RECHARGEABLE BATTERY CHANGE

CR-78

MANUAL CHANGE INFORMATION

4N-100AA (5.6V) to N-SB3 (3.6V)

CR-78 GL-9B (142-009B) (Etch mask 052-438B) Serial No. 821051 and higher

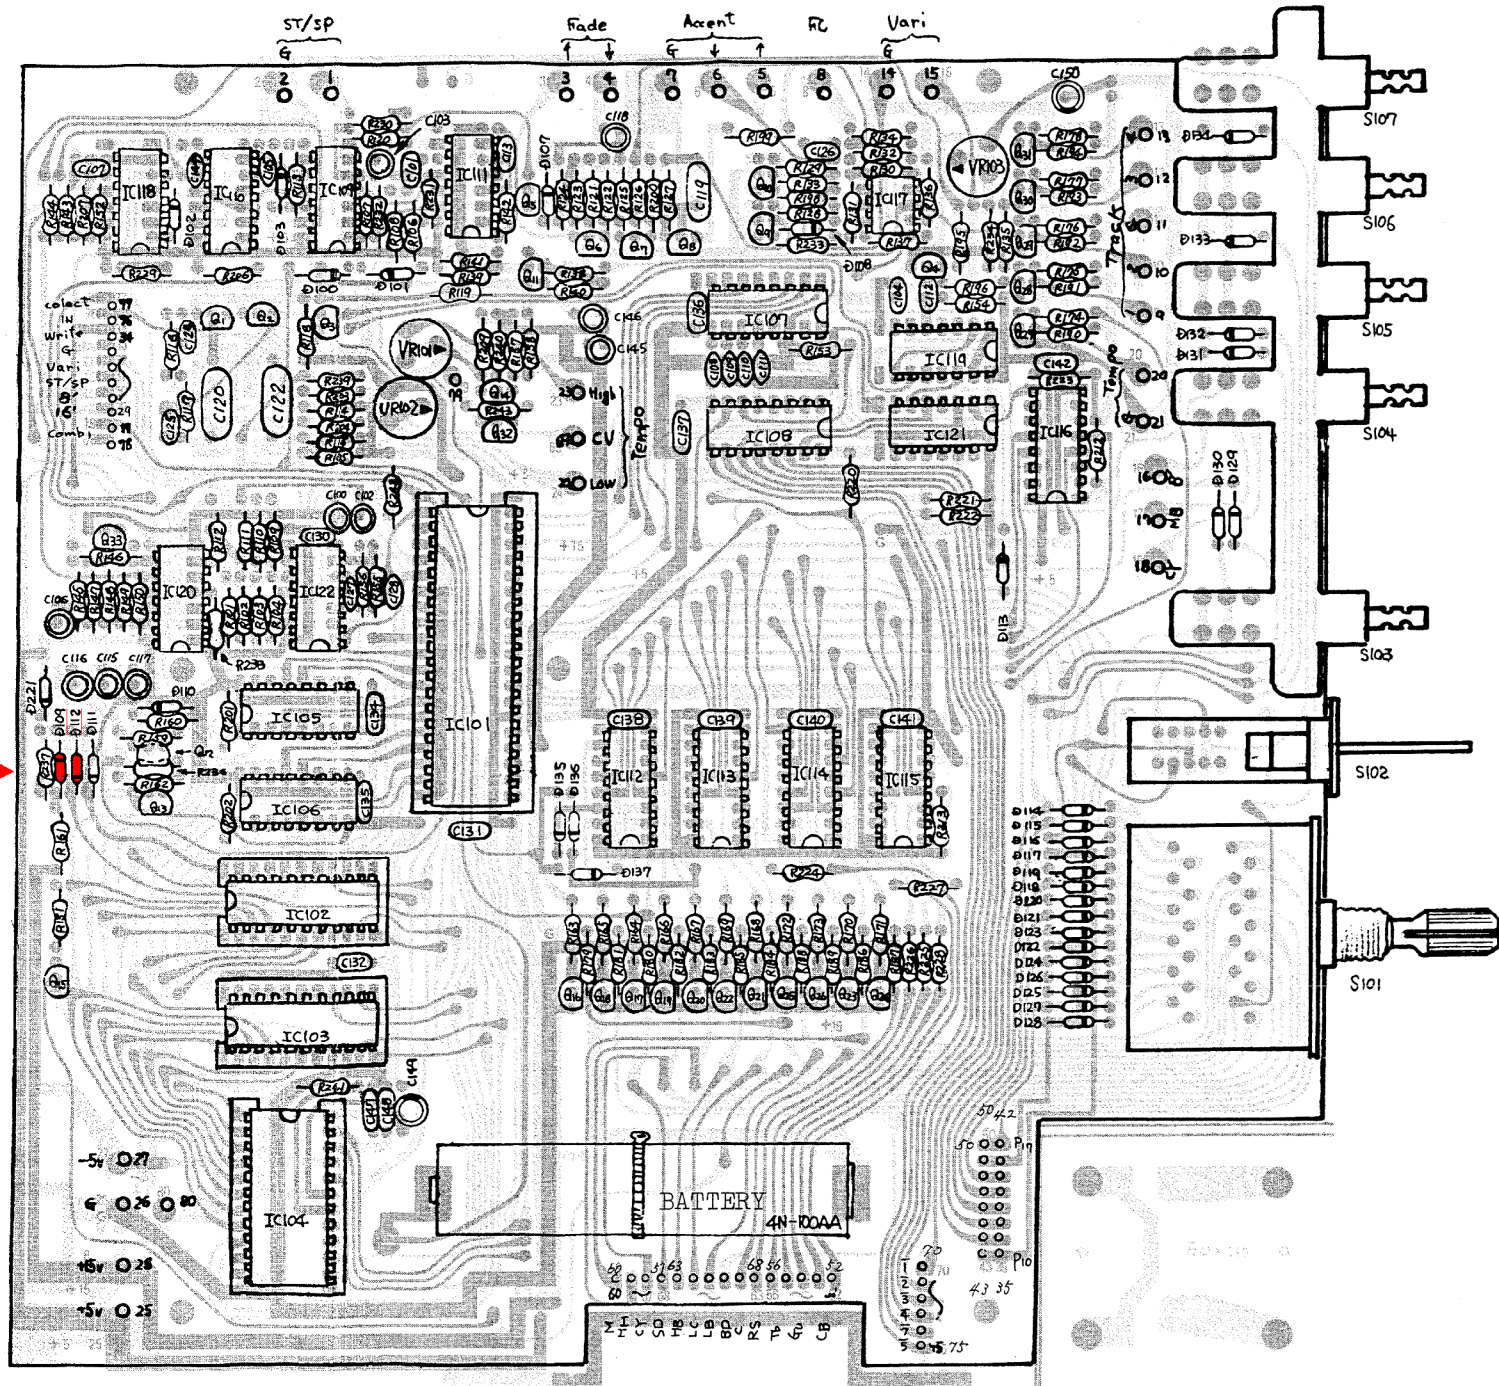
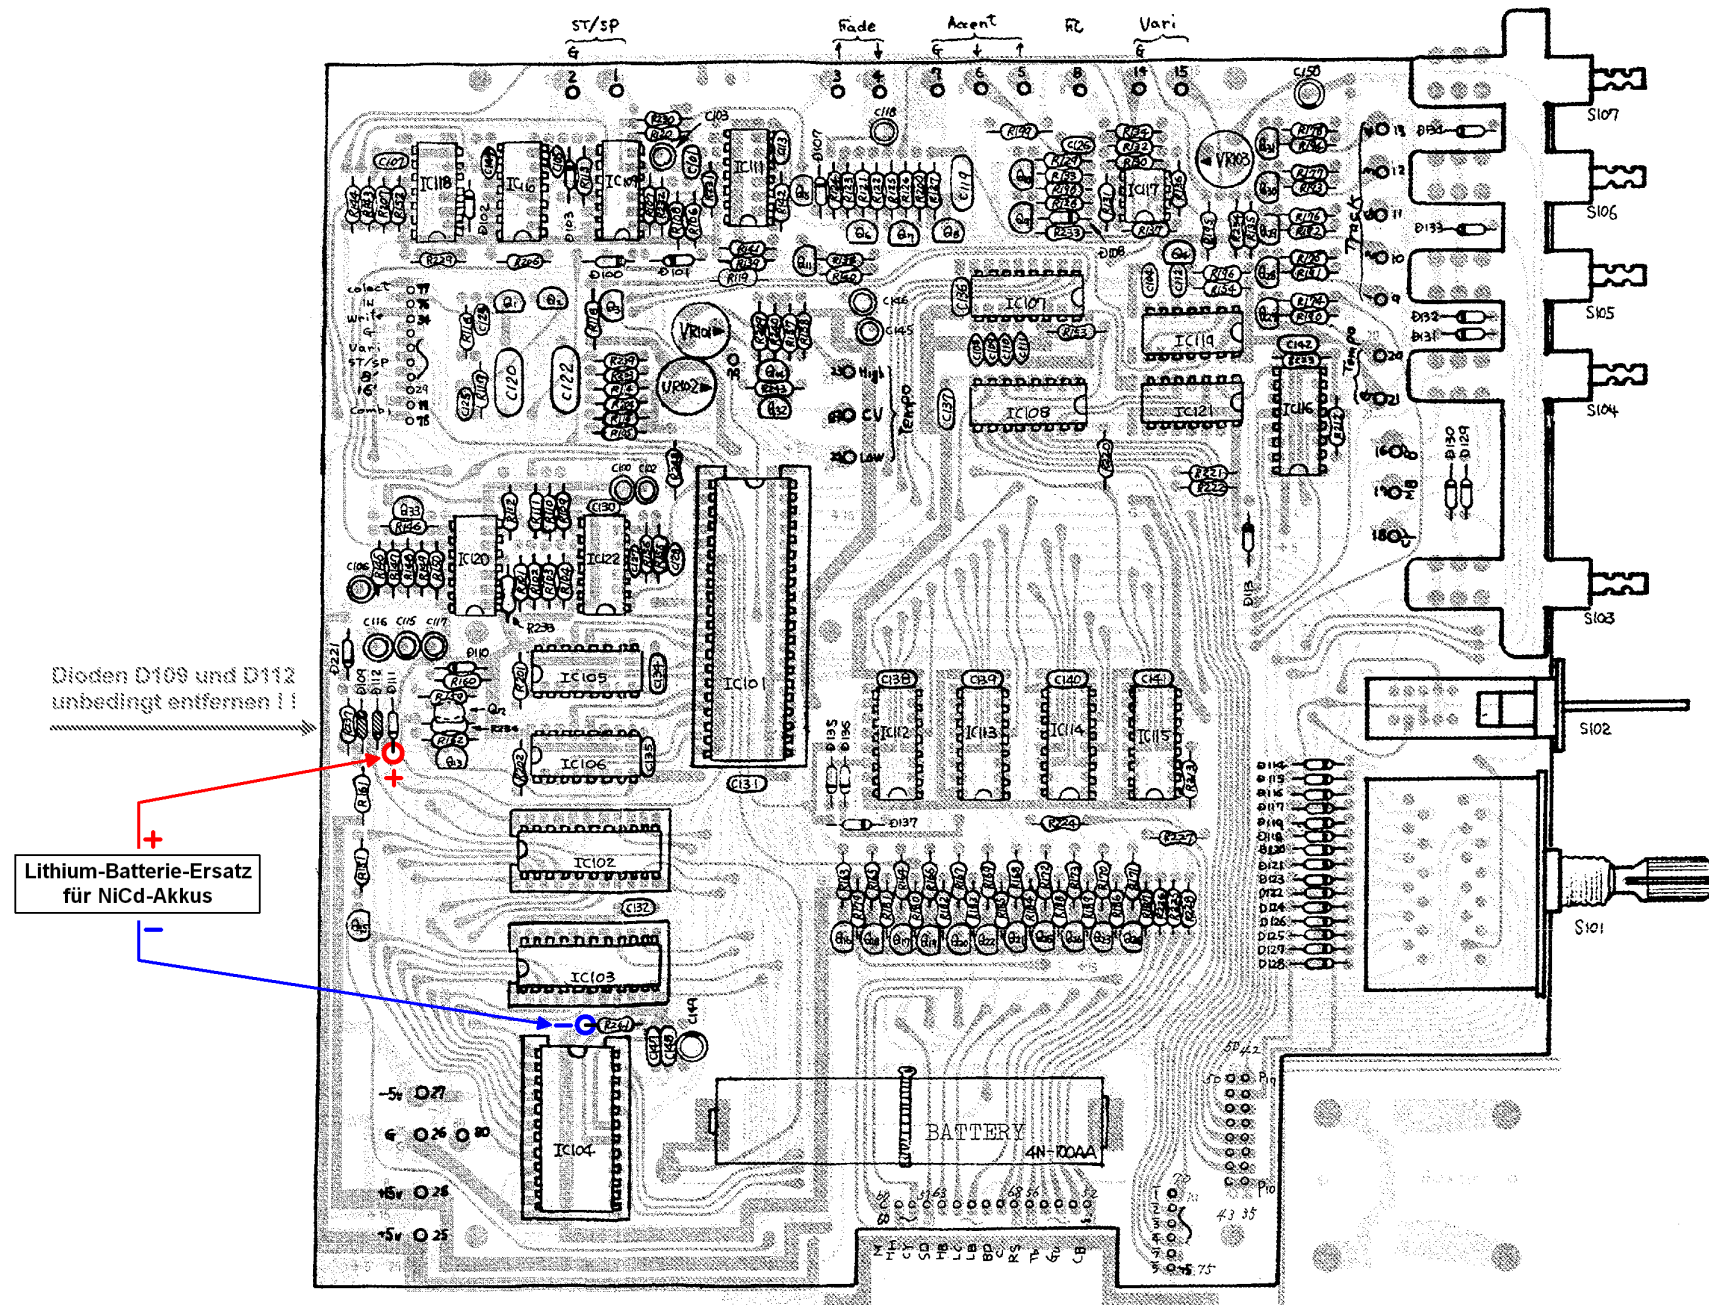
Dioden D109 und D112
unbedingt entfernen !!

GL-9 with 4N-100AA

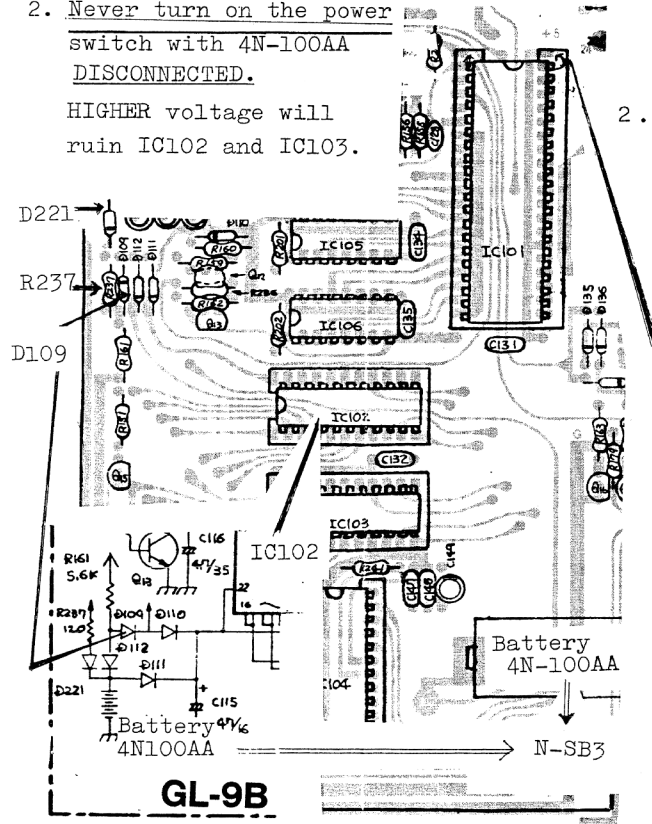
1. D109 is removed at the factory
to increase charging current.
However, there are some products
having D109 on the market.
REMOVE D109 on the first occasion.

2. Never turn on the power
switch with 4N-100AA
DISCONNECTED.

HIGHER voltage will
ruin IC102 and IC103.

(after D109 removed)

VG-11A Fulfilled part designation —
not denoted or misprinted
on the service notes.

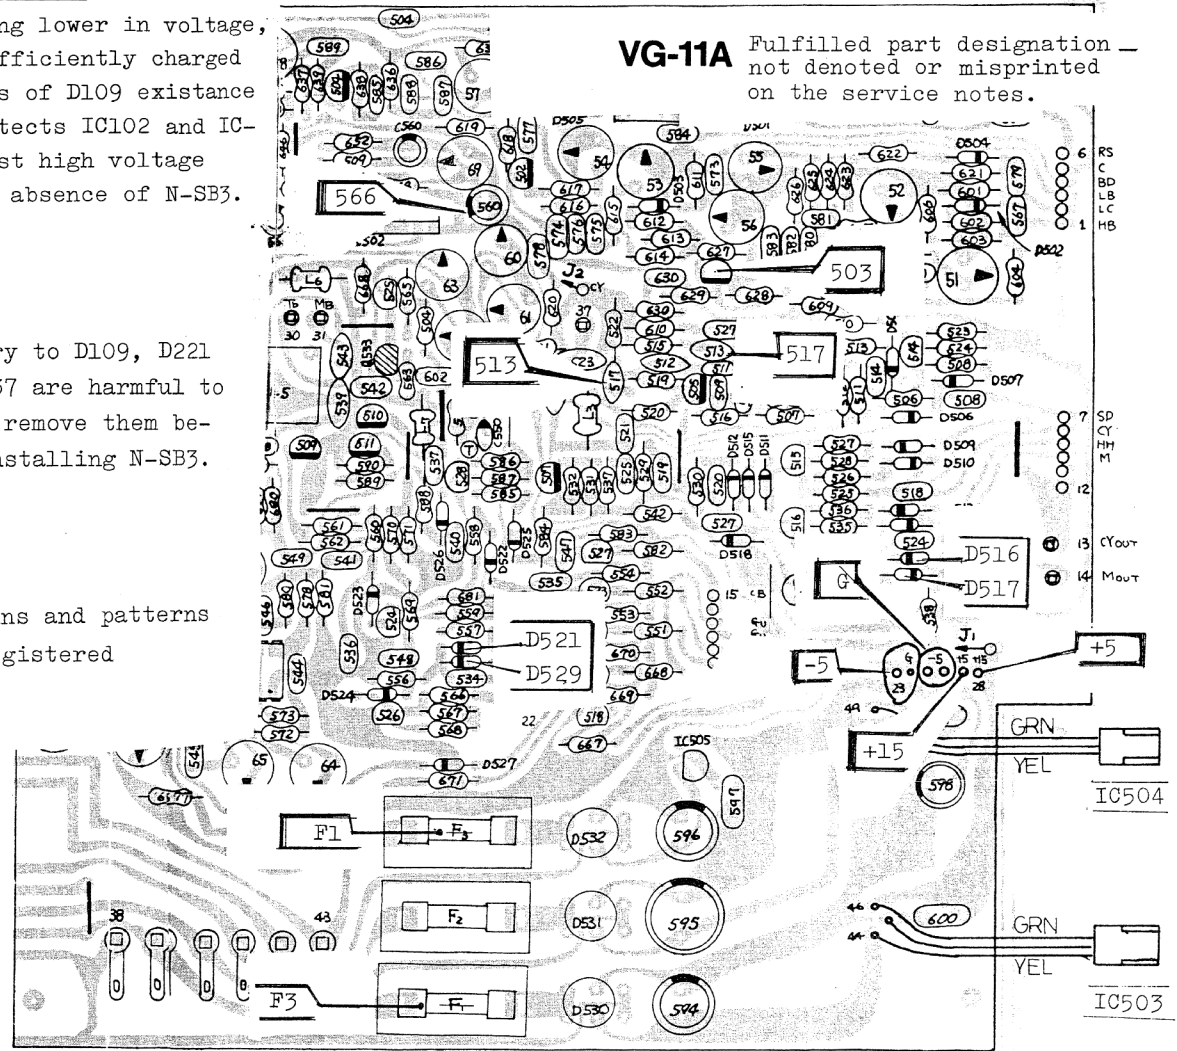
IC pins and patterns
misregistered
